TECHNICAL BULLETIN INDEX
Sorted by Bulletin Number
04/03/86

BULLETIN NO.: I:1

PRODUCT: 26-1140/1/2 Expansion Interface

Figure 2. XRX-III Modification Schematic.

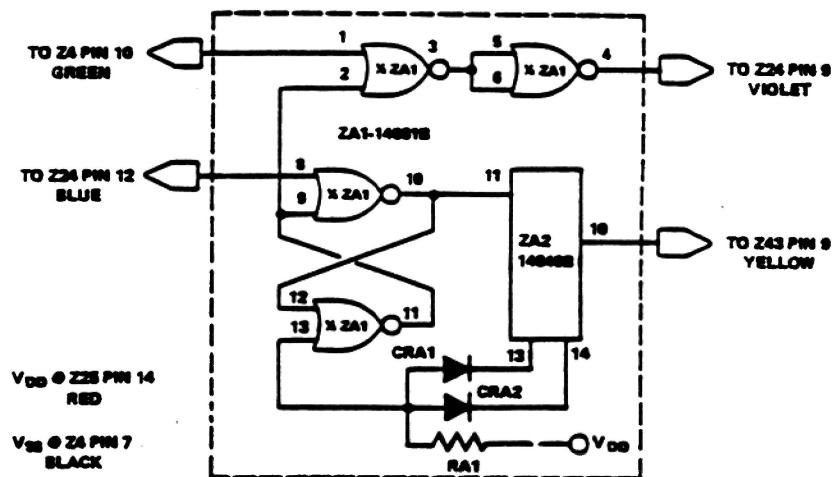
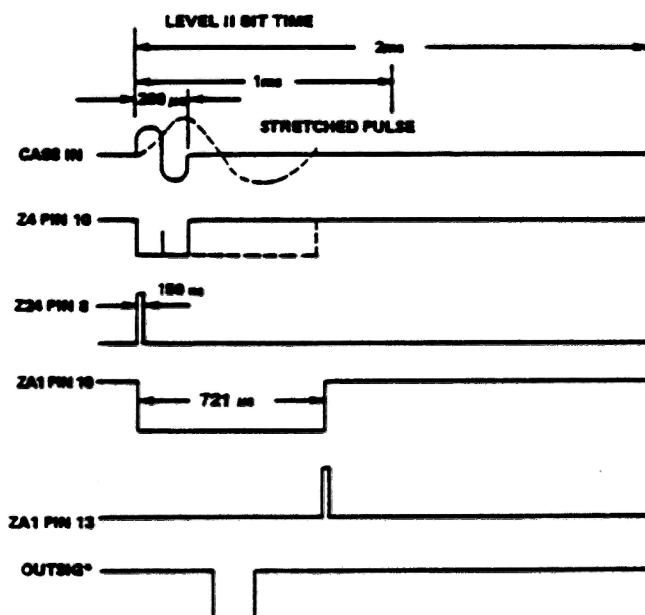
Refer to Figures 2 and 3 for the following discussion. The XRX-III cassette modification works on the theory of re-setting the R/S Latch, Z24, just as the OUTSIG* line would do, but before the OUTSIG* line does. In this manner, we allow for a stretched audio CASSIN signal (due to poor cassette motor speed control and high-volume stretching) and use only the edge trigger level of the CASSIN signal bit. The remaining stretched CASSIN signal is totally ignored by the CPU's test bit signal at Z44, Pin 15.

The RXR-III is essentially a controlled inhibit signal used to halt stretched waveforms and thereby increase loading volume levels. ZA1 is dual functional. Pins 1, 2, 3, 4, 5 and 6 form a control gate with an inverted output that controls the amount of cassette pulse that is used for setting bits into the CPU. Normally, pin 2 will be at a logical low. When the first cassette pulse is received by ZA1, Pin 1; ZA1, Pin 4 will output a negative going pulse which is detected by the R/S Latch, Z24, Pin 4. This sets the R/S Latch. Z24, Pin 8 will go high and Z24, Pin 11 will go low.

Z24, Pin 8 is used to set the R/S Latch contained in ZA1. This R/S Latch is the second function of ZA1 and is formed by Pins 8, 9, 10, 11, 12 and 13. When ZA1, Pin 11 goes high, ZA1, Pin 10 goes low. ZA1, Pin 11 is used to inhibit the gate at ZA1, Pin 2. This causes ZA1, Pin 4 to go back high and remain high until ZA1, Pin 2 goes low again. Information is passed through gate ZA1, Pin 4 only when ZA1, Pin 2 is low. Control of the amount of time that ZA1, Pin 2 stays high is performed by ZA2. ZA2 is a 12-bit Binary Counter.

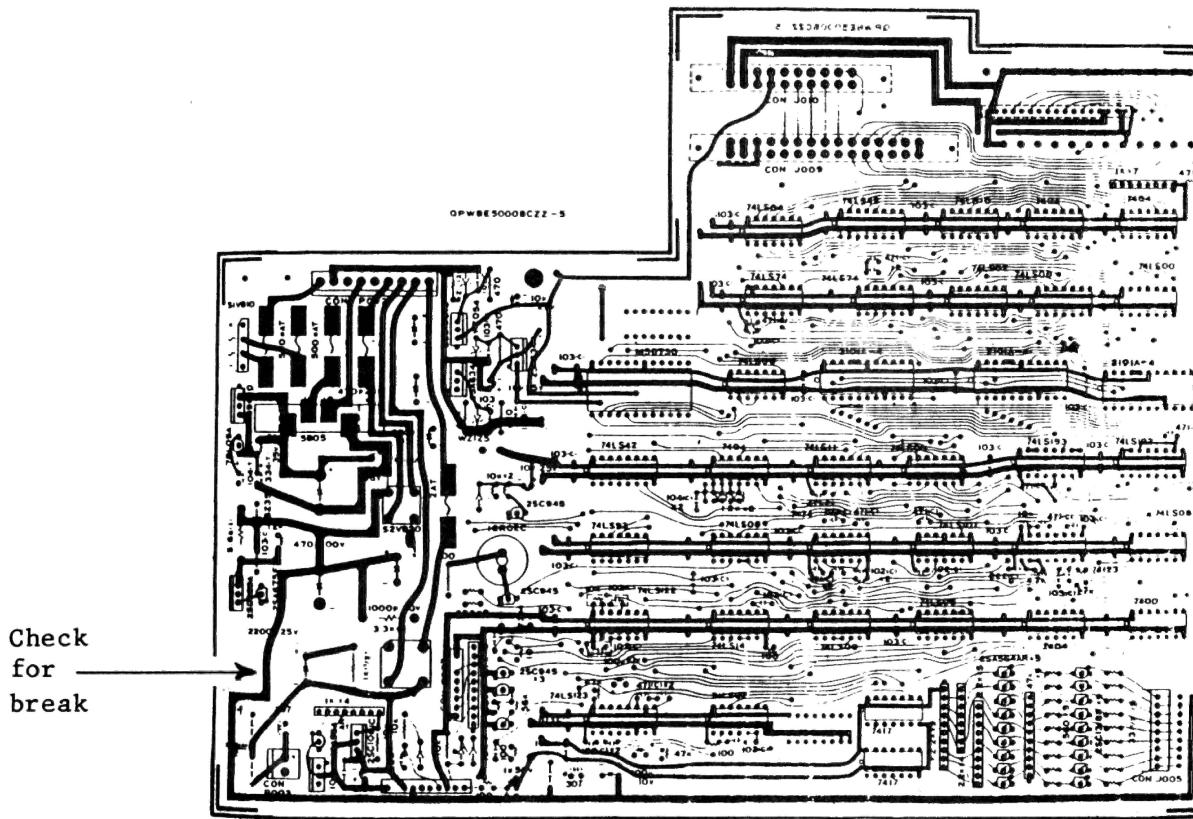
If the unit runs, head carriage travels, but it does not print, check for a broken -34 volt trace on the PCB next to the heat sink.

Figure 1 Rev. B

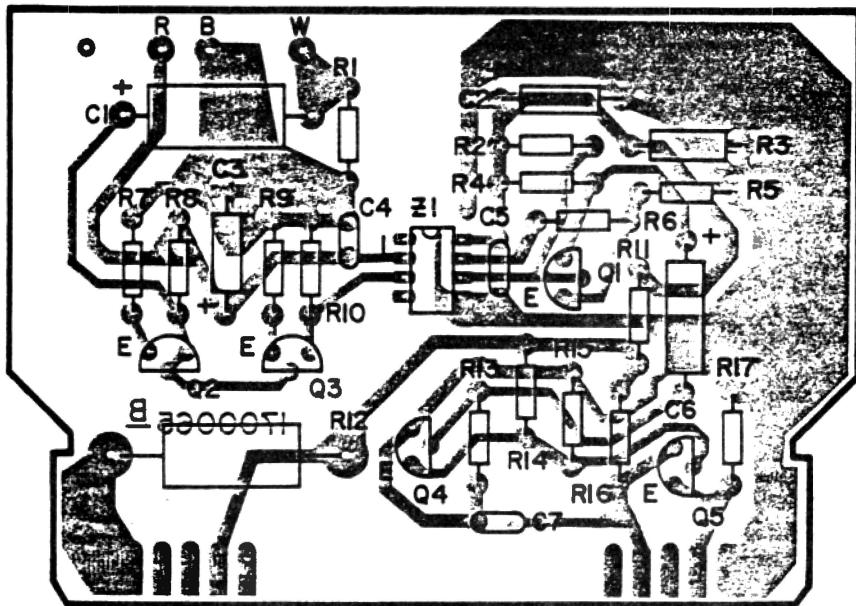
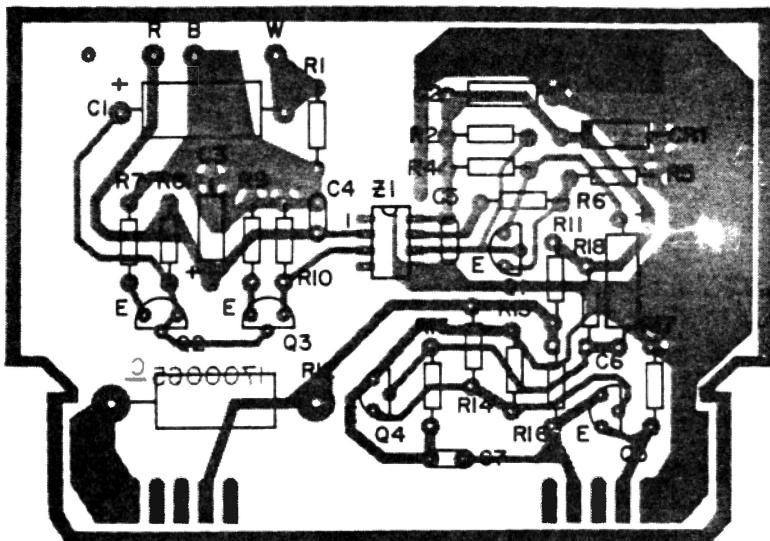
Refer to figures for component locations.

1. Delete R3, and replace it with a 12volt, 1 watt, Zener diode such as 1N4742.
2. Add R18, 68K, 1/4 watt, 5% resistor from the junction of R11, C2 to the junction of C6, R13.

Note: Some revision boards may have R18 as 220k, in which case change to 68k value.
3. Change the value of resistor R13 from 22K, 1/4 watt, 5%, to 6.8K, 1/4 watt, 5%.
4. Change the value of resistor R16 from 1K, 1/4 watt, 5%, to 2.2K, 1/4 watt, 5%.

R3 (CR1) = 1N4742 diode (Nat'l Parts# ADX-1150 26-1150).
R13 = 6.8K ohm resistor (Nat'l Parts# AN-0262EEC 26-9999R).
R16 = 2.2K ohm resistor (Nat'l Parts# AN-0216EEC 26-9999R).
R18 = 68k ohm resistor (Nat'l Parts# AN-0354EEC 26-9999R).

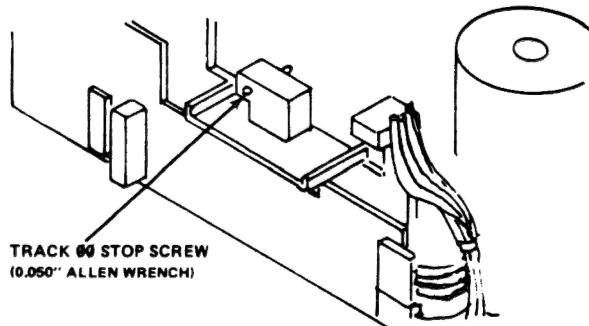
Early Tandon disk drives were not equipped with track 00 stops. Drives without the stop can jump to track -04 on power up causing the drive to not boot unless the head is moved by hand to an inside track.

Remove the rear guide rod clamp screw. Using the long screw supplied with the kit, install the Track 00 stop on top of the rod clamp. Install the hex screw, also supplied with the kit, from the rear screwing it in until it just appears through the other side. Assemble the drive and run the TDC alignment program, adjusting the hex screw as necessary.
